CITY OF ALBUQUERQUE

RE: Sawmill Tract H, 1921 Bellamah Ave. NW
Grading & Drainage Plan
Engineer's Stamp Date: 1/4/2023
Hydrology File: J13D017B

Based upon the information provided in your submittal received 2/3/2023, the Grading & Drainage Plan is not approved for action by the DHO on Site Plan for Building Permit Approval. The following comments need to be addressed for approval of the above referenced project.

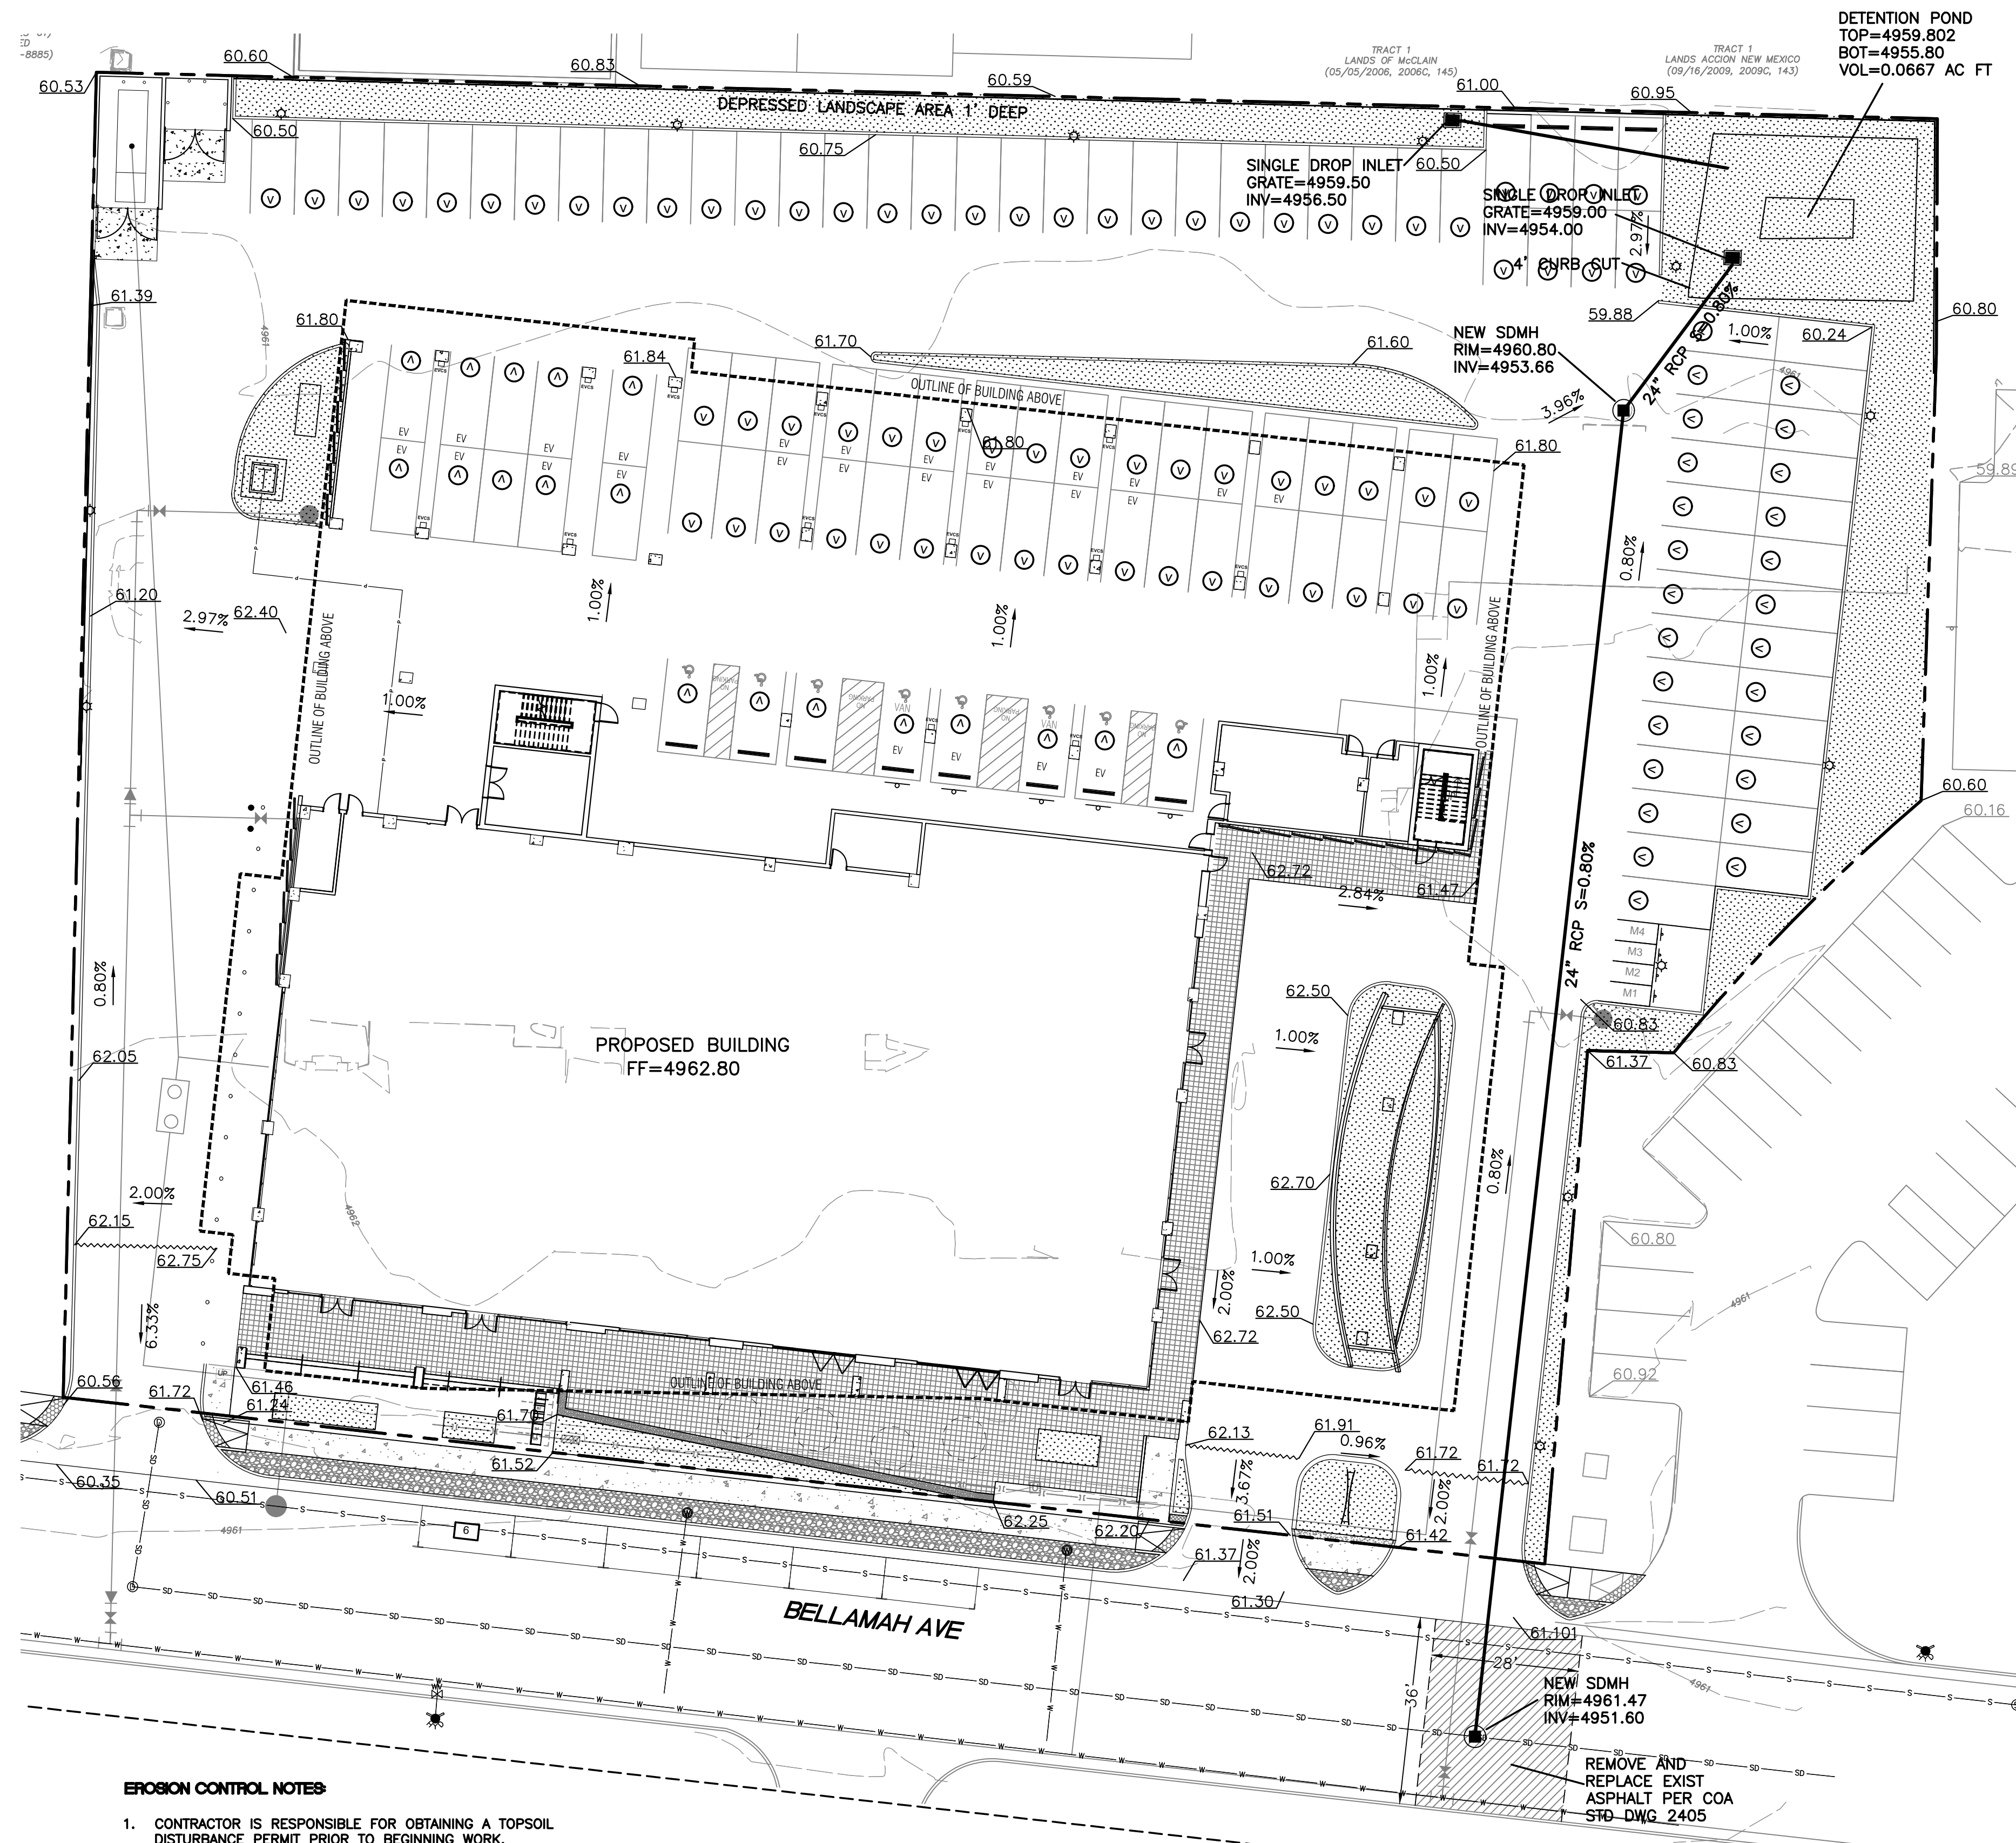
1. Please provide pond 2 location, volume and cross-section on sheet #GR-1.
2. Show the bioswale for proposed basin 1.
3. On sheet #GR-1, Proposed Drainage: It states that "The pond in basin 2 will retain the developed runoff of 0.036 ac-ft which is less than the required water quality volume of 0.40 ac-ft". – This statement is confusing. First of all, the retention pond volume should not be less than the SWQV. Secondly, would pond 1 volume be counted for part of the SWQV? Please clarify. Also, the required SWQV is 0.04 ac-ft, not 0.40 ac-ft. This might be a typo.
4. On the same sheet: The next sentence states that "The pond will drain 7.15 cfs. Therefore the total discharge from the site will be 8.09 cfs". – Please provide calculations showing that where these number come from.
